HOLGATE 12 APARTMENTS II

2nd EARLY DESIGN GUIDANCE

1808 12TH AVE. S.
PROJECT # 3018185

MARCH 10, 2015

OPTION E & F
ENTERING
DOWN
THROUGH
FRONT YARDS

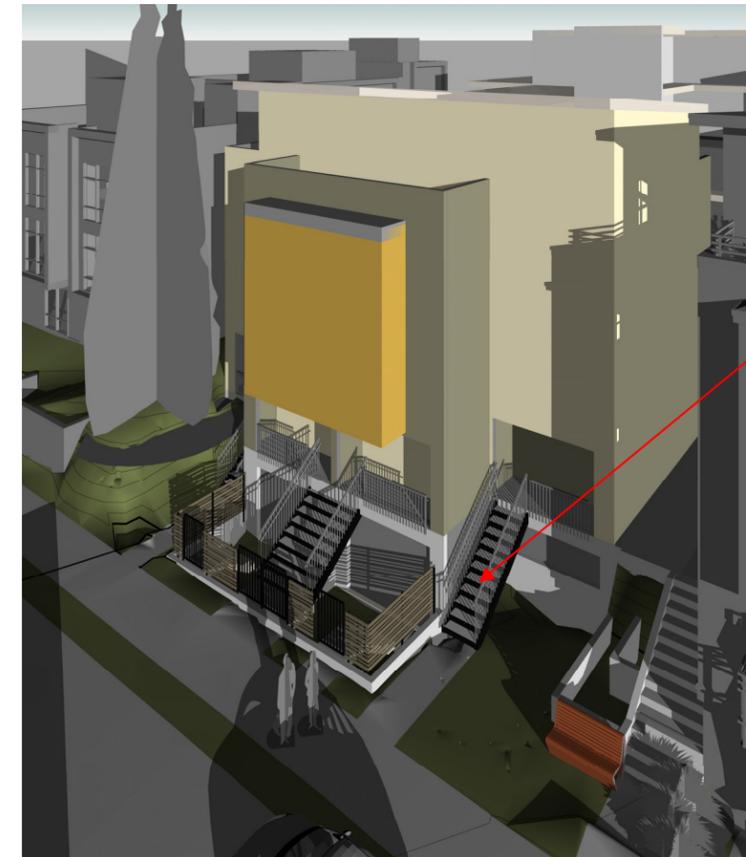
b. The Board recommended ground level or walk up residential entries. Below sidewalk level entries are not desirable by the Board. The Board noted that the same attention should be given to the residential units at ground level along the alley as those that have street frontage. (CS2-B, CS2-C, PL3, DC1-A, DC3-B, DC3-C) (continued)

The amount of stairs in Option G also creates a wall that hides the base structure of the 1st level and limits the connection from the interiors of the building and doesn't meet Guideline CS2-B to create a strong connection to the Street.

Proposed solution for preferred Option's E & Option F is to set the building further back from 8' in the previous Options A-D to 10' from the street to increase the size of the garden to allow the transition down more space and the person stepping down the 4 to 5 risers to adjust to the garden level before entering the unit.

OPTION E; Courtyard, Modulation to save Deadora Cedar

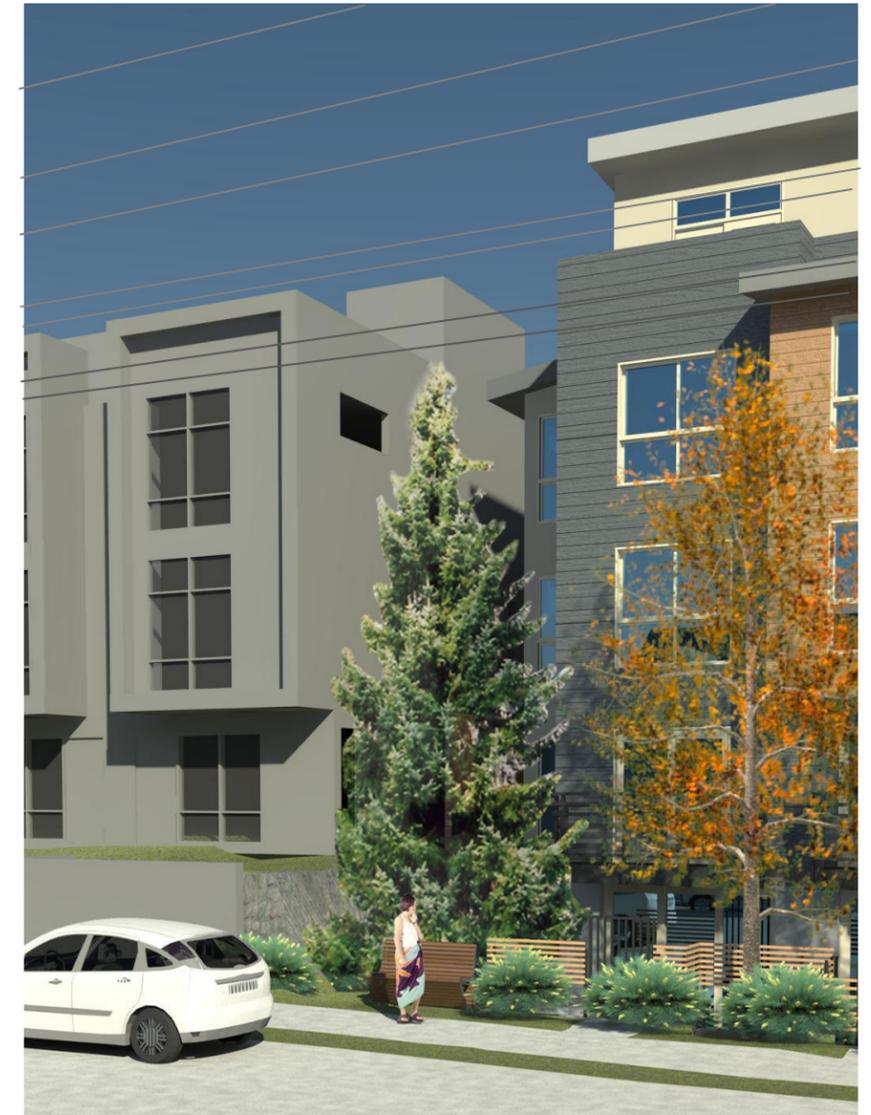
The Board agreed that the retention of the northwest tree is important and discussed that the design for the northwest portion of the building façade needs to respond to the siting of the northern building.

The front of the building has been modulated to create a space to save the tree which is about equal to the existing space. The rockery that the tree is growing in will also be preserved. The base of the existing tree is above the sidewalk by about 6 feet.

In order to create a pedestrian amenity at sidewalk level an alternative street tree is proposed to replace the Deadora Cedar with another conifer (Serbian Spruce) at sidewalk level. This alternative tree is selected to be more suitable to the space under the power lines. With this alternative a bench could also be added to create a quasi public space.

OPTION E (preferred) Modulations

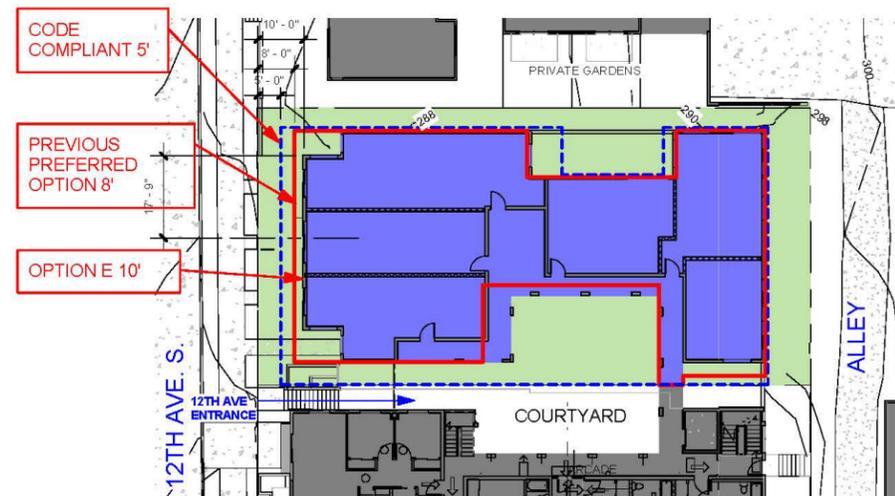
a. The Board recommended modulating the building, while keeping a strong residential street edge at the first floor. (CS2-B, DC2-A, DC2-D, DC2-E)

Vertical Modulations of about 6'-7' wide and 8' deep have been added in preferred Option E. 12' wide x 8' deep added in Options G in both the NW and SW corners and about a 7' wide x 7' deep in the NW corner and 2 modulations one 5' wide and 8' deep modulation in Option F. Option F also has an additional 11' wide & 6' deep modulation in the SW corner on the 2nd level.

These modulations add to the visual separation between the proposed addition and the Townhouses to the North and the Existing Building to the South to meet DC2-A2 to reduce the perceived mass of the building. These modulations also create open space for saving the existing Deadora Cedar Tree and for a new public entrance at 12th Ave S. into the Basement Level of the building.

The Majority of the Front façade has been setback further from 8' in the previous Options to 10' to be about the same setback for the upper levels of the Townhouse to the North.

OPTION E PREFERRED; NORTH ELEVATION WITH TOWNHOUSE OVERLAY

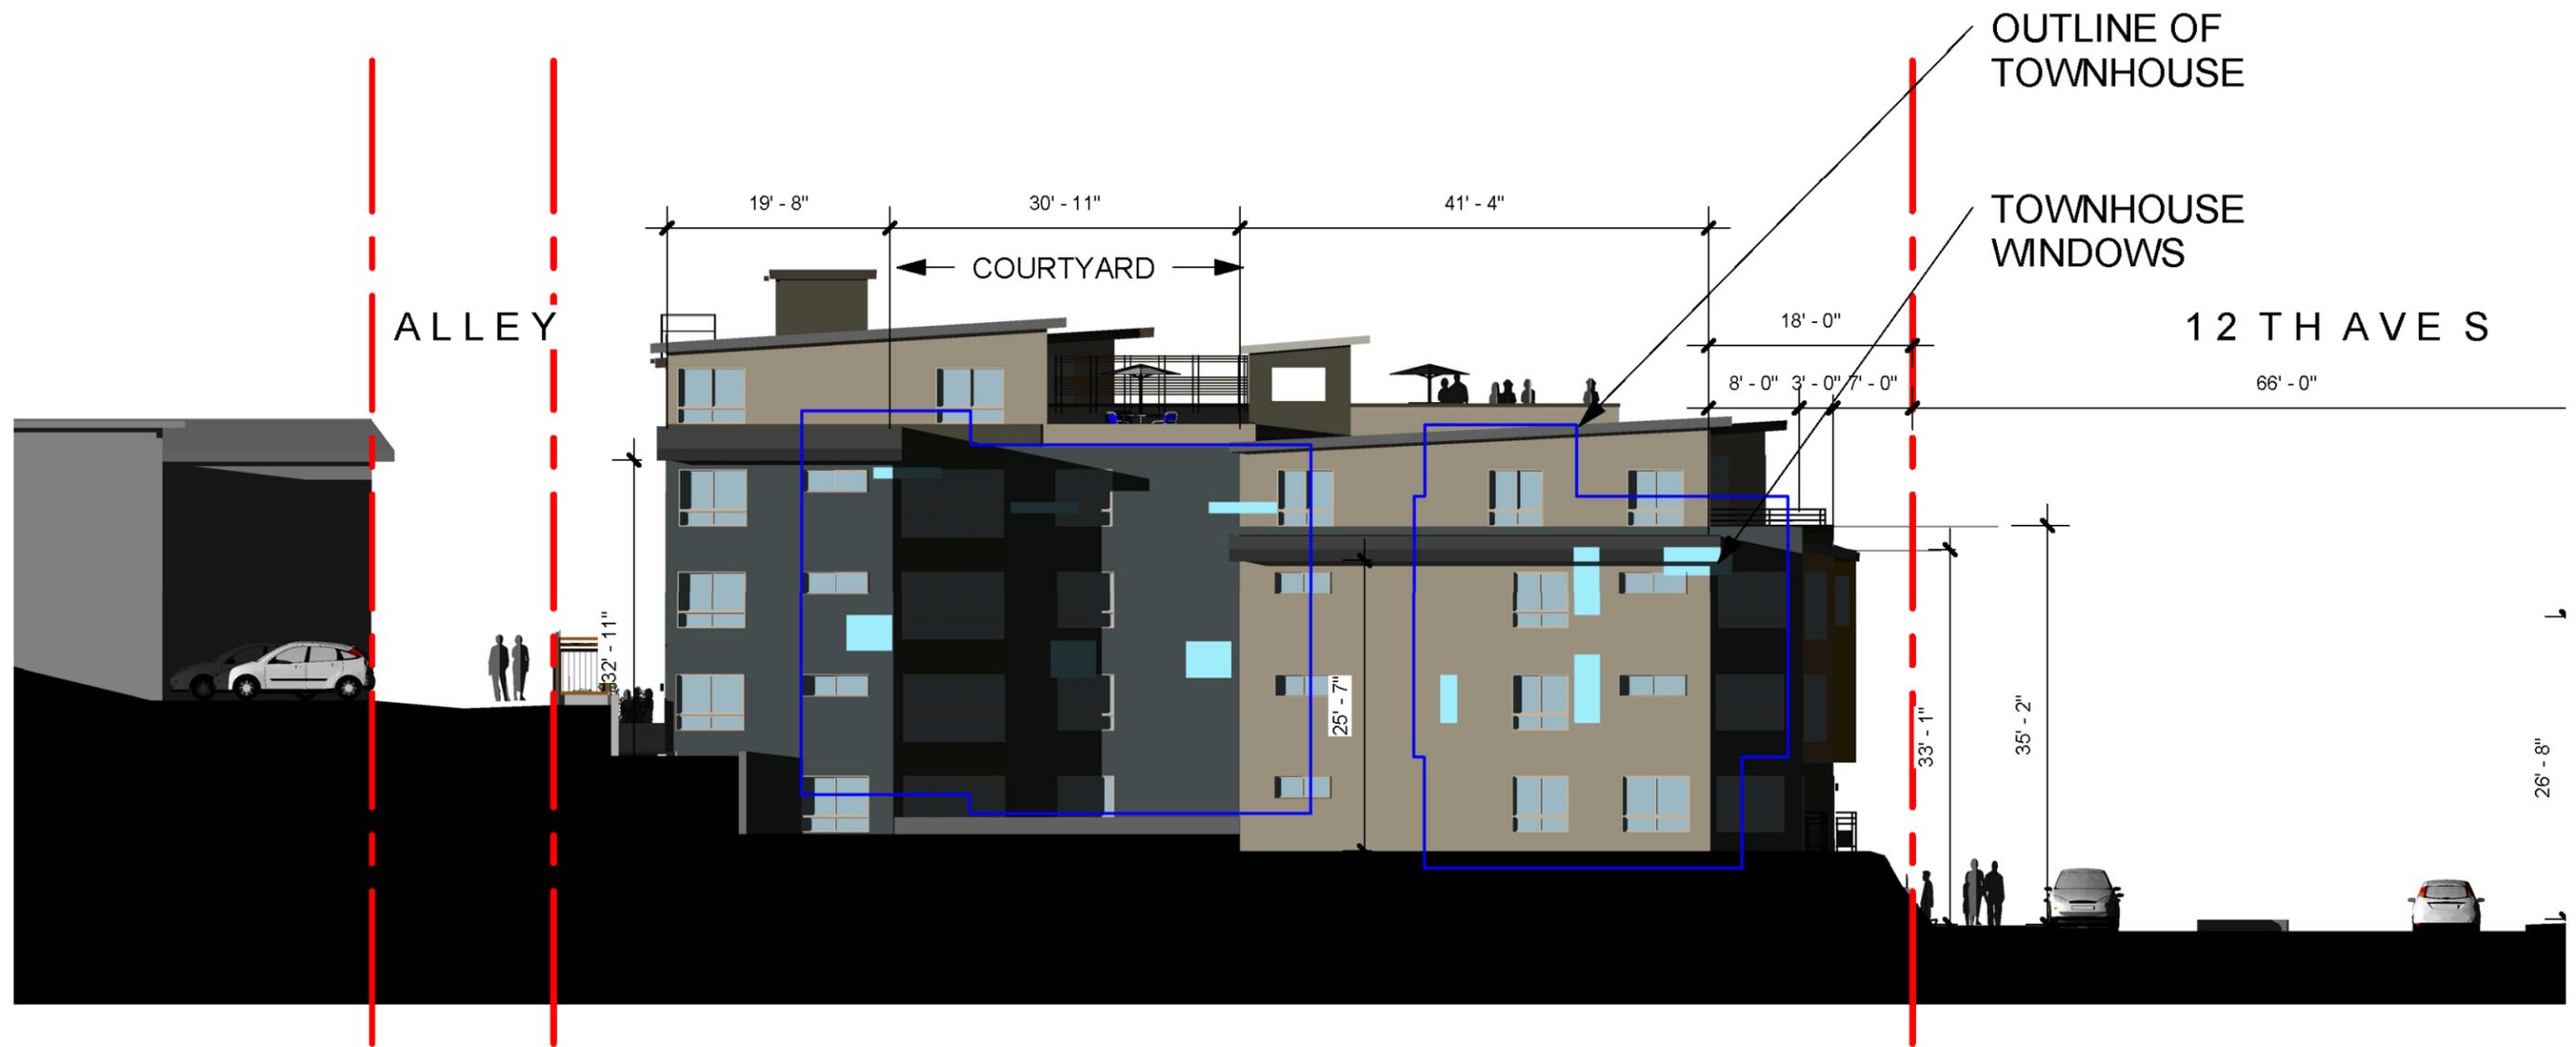
b. Adjacent development was discussed, and the Board agreed that modulation of the structure along the north property line was desirable and ground level landscaping should be considered. (CS2-B, CS2-C, CS2-D, DC2-A)

In Options G (Townhouse) & preferred Option E (Courtyard) the Building is modulated both vertically with a 30' wide courtyard along the North side at the location of the Townhouse private Gardens and in all Options horizontally by stepping both the 4th floor back about 5' at the front of the building along the North property line and about 10' at the 5th floor along the North property line at the rear of the building to meet CS2-D2.

Shed roofs have been created at these levels in all Options along the North property line to further reduce the perceived mass. By locating the 30' wide courtyard at the private gardens also helps to meet CS2-D5 minimize disrupting the Townhouse's private gardens and outdoor activity.

Option F (No Courtyard) maximizes the façade length allowable at the North Property Line and does not meet these Design Guidelines as well as Option G (Townhouse) & E (Courtyard).

OPTION E (preferred) Option G Similar

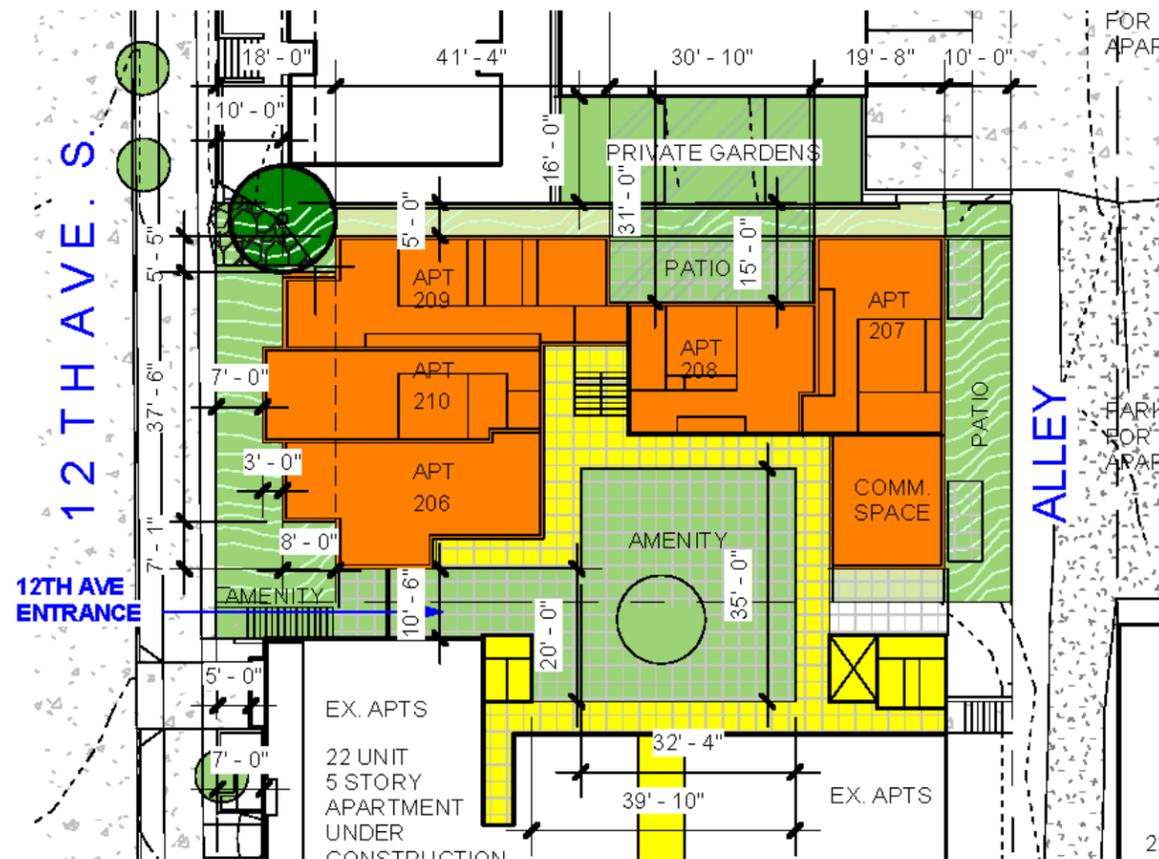
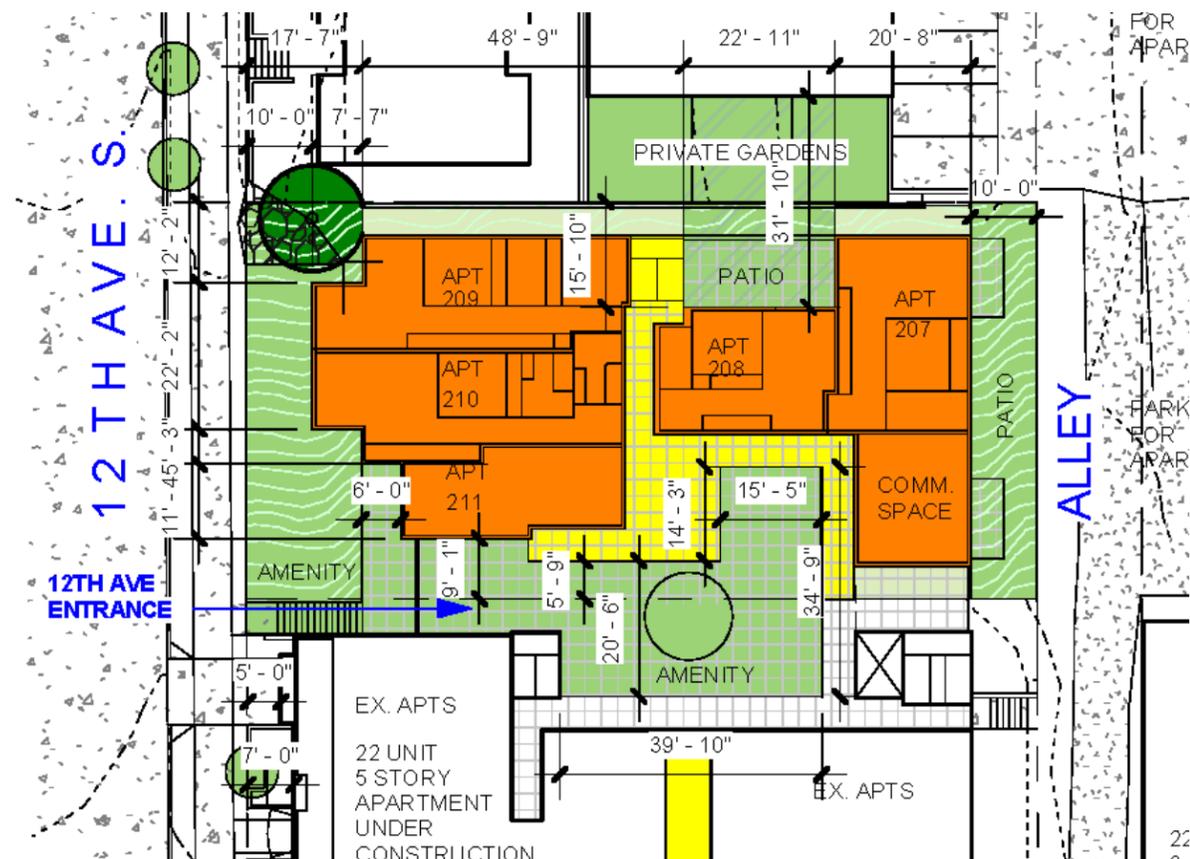
c. The Board was concerned that the courtyard from 12th Ave S only addressed the onsite users of the two structures. The Board stressed that development of a strong open space concept that sets a positive precedent is critical. (DC1-A, DC3)

The Main Courtyard has been reduced in size from the previous Options in preferred Option E & Option G to create an entry courtyard at 12th Ave S with a new public entrance an open space to save the existing Deadora Cedar and enlarge and connect to the other existing open spaces and better respond to both of these Design Guidelines DC1-A & DC3 to connect to and create larger contiguous open spaces with other public and private development . The entry courtyard connects to the street and is an extension of the main courtyard and along the pedestrian path from 12th Ave through the courtyard to the resident's units.

The enlarged Main Courtyard in preferred Option E & Option G is able to meet Design Guideline DC-1A to locate gathering spaces at the highest levels of pedestrian traffic. Option F only minimally adds to the existing courtyard of phase I to the south and the townhouse gardens to the north and is not enlarged enough to add a gathering space at the highest level of pedestrian traffic and so does not meet this Design Guideline.

OPTION E; Courtyard, (preferred) Common Roof Deck

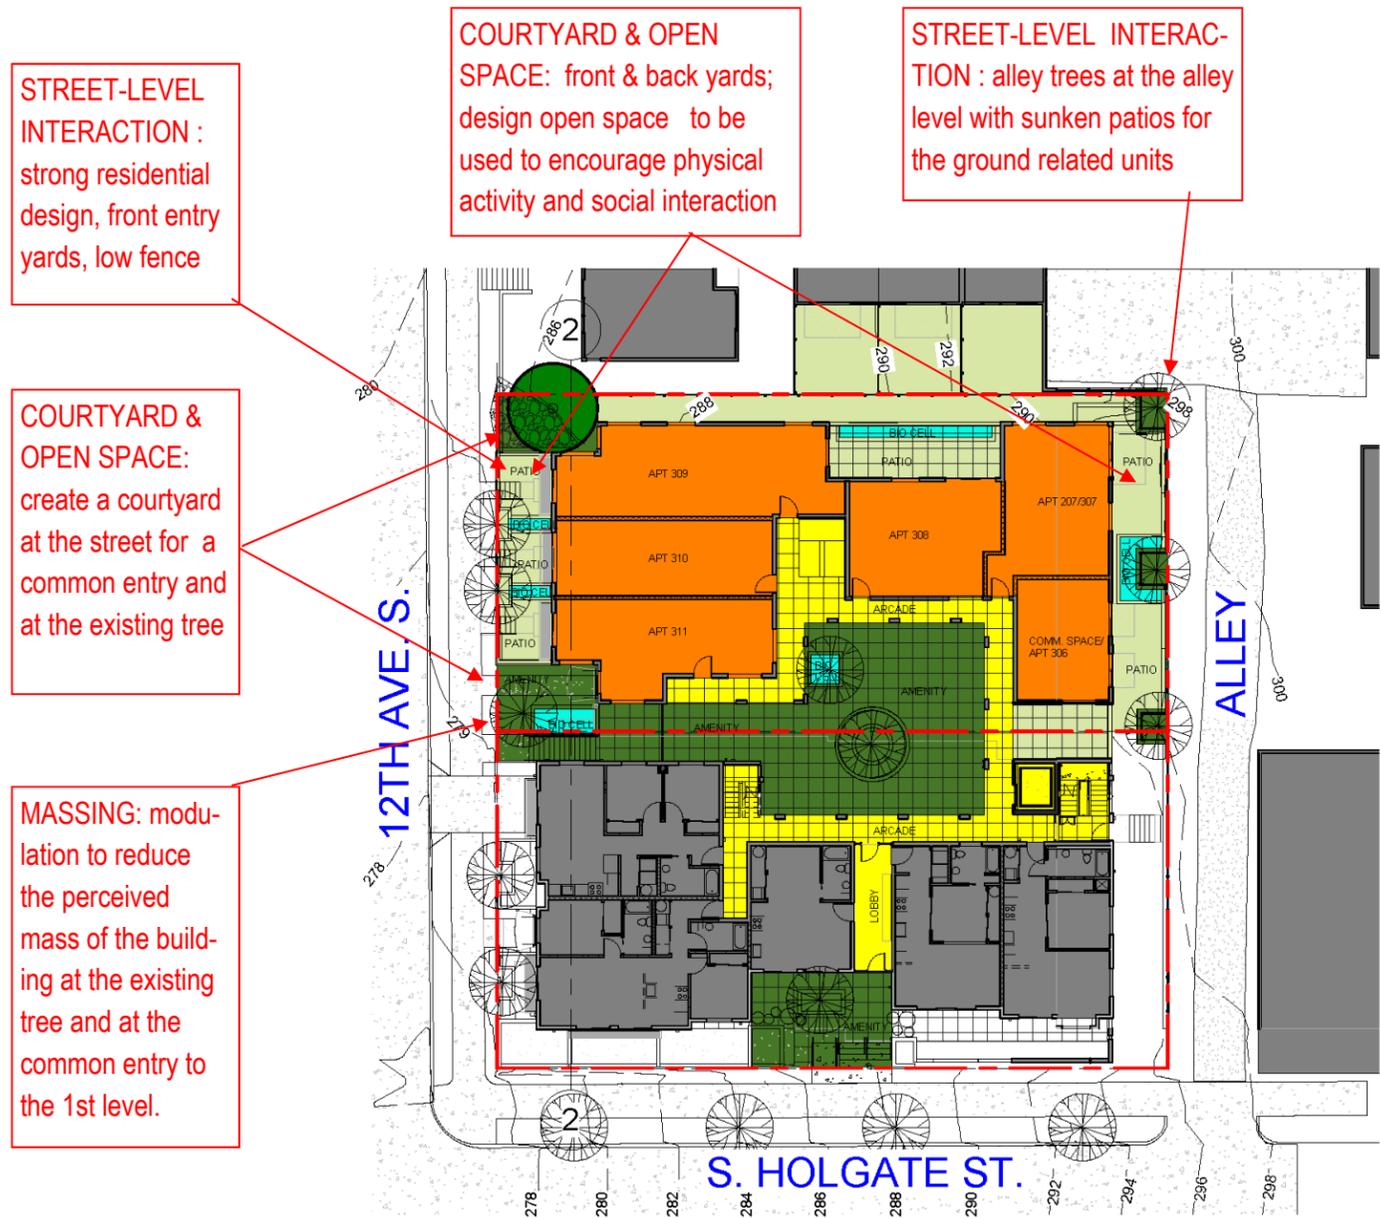
- a. The Board acknowledged that it may be difficult to provide upper level decks that do not impact the privacy of the adjacent properties; however the design must be sensitive to this condition and this needs to be addressed at the next meeting. (PL3, DC1-A, DC1-B, DC2-A, DC3-B, DC3-C, DC4-D)
- b. The Board encouraged further development of the rooftop decks. (PL3, DC1-A, DC1-B, DC2-A, DC3-B, DC3-C, DC4-D)

In all Options The Common Roof Deck has been designed to use the South portion of the roof and to set back almost 30' from the front property line to meet CS2-D5 to minimize disrupting outdoor activity on the adjacent properties.
